SI B11 06 13
Engine

Service Action: Retrofit Bracket for EGR Cooler

E70 (xDrive35d)

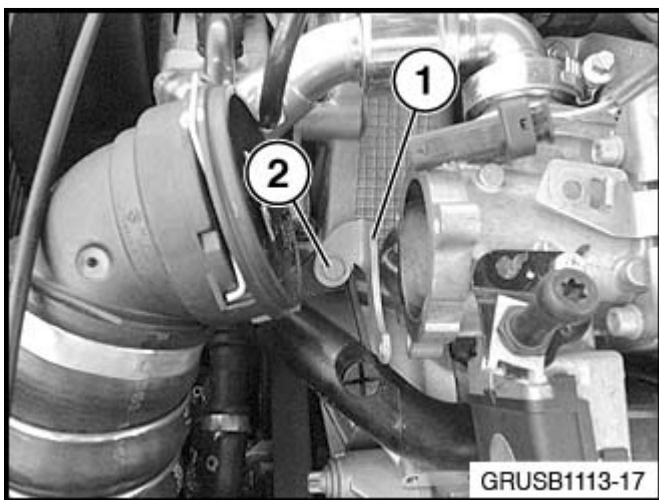
The flexible pipe on the high-pressure Exhaust Gas Recirculation (EGR) cooler may leak.

Excessive vibration and/or tension at the flexible elbow of the EGR cooler can cause it to leak.

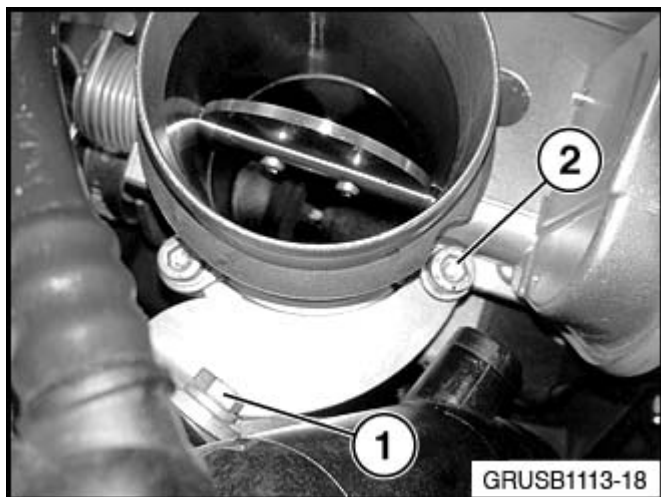
Install bracket P/N 13 54 8 576 446 (1) to the cylinder head using the bolt P/N 07 11 9 904 527 (2). Leave this bolt finger tight until after the throttle valve is reinstalled.

Reinstall the throttle valve and snug down all three throttle valve screws. Torque the two screws that are not attached to the new bracket to specification (8Nm). Tighten down the bracket bolt on the cylinder head (1) to 8Nm. Tighten the screw (2) holding the bracket to the throttle to 8 Nm.
